**CHRYSLER**

Dealer Service Instructions for:

Customer Satisfaction Notification P38 Power Distribution Center Cover Label

- 2014 (DD) RAM Cab Chassis (3500 series)
(DJ) RAM Pick Up (2500 series)
(DP) RAM Cab Chassis (4500/5500 series)
(D2) RAM Pick Up (3500 series)

Figure 2 – Correct Fuse Callout on PDC Cover

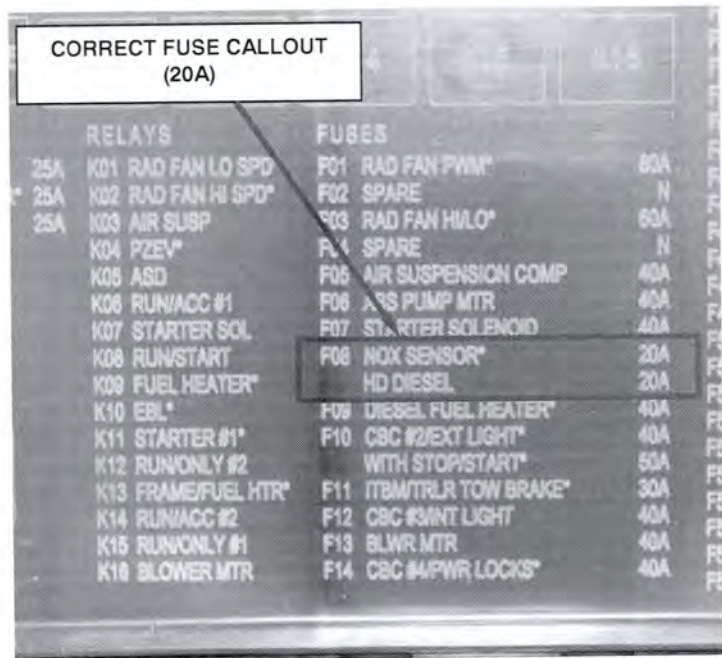
The Power Distribution Center (PDC) cover fuse label on about 21,000 of the above vehicles may have the incorrect fuse size specified for the fuse F08, Oxides of Nitrogen (NOx) sensor. The original label specifies a 30 or 40 amp fuse, but the correct fuse size is 20 amps.

4. Inspect the PDC cover laser etching (Figure 2).

- If the laser etching on the PDC cover states “NOx Sensor 30A or 40A” and “HD Diesel 30A or 40A” continue to **Step 5** (Figure 2).
- If the laser etching on the PDC cover states “NOx Sensor 20A” and “HD Diesel 20A” continue to **Step 7** (Figure 2).

Figure 3 – PDC Cover Fuse Label Installed

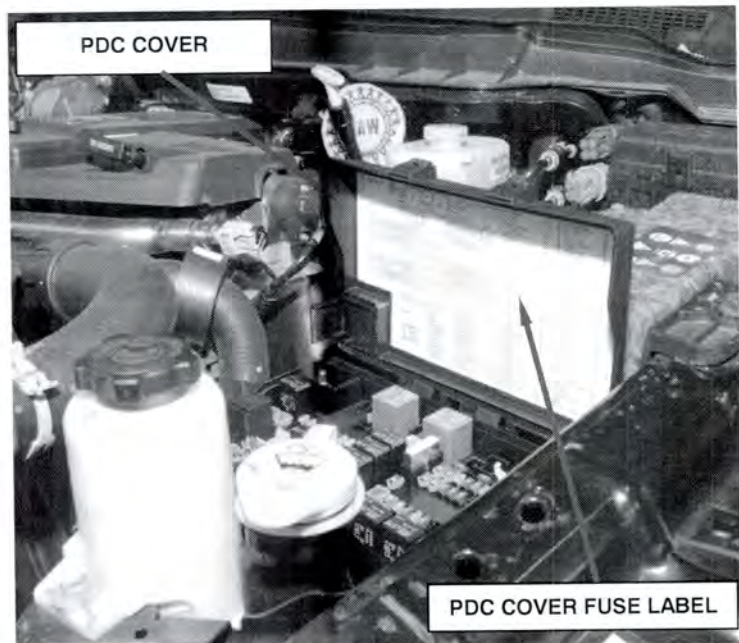
A new PDC cover fuse label must be installed over the original laser etching.

6. Remove the new PDC cover fuse label from its backing paper and carefully install it over the existing PDC laser etching (Figure 3).

NOTE: Firmly press and smooth the new PDC cover fuse label to the existing PDC cover to ensure good adhesion.
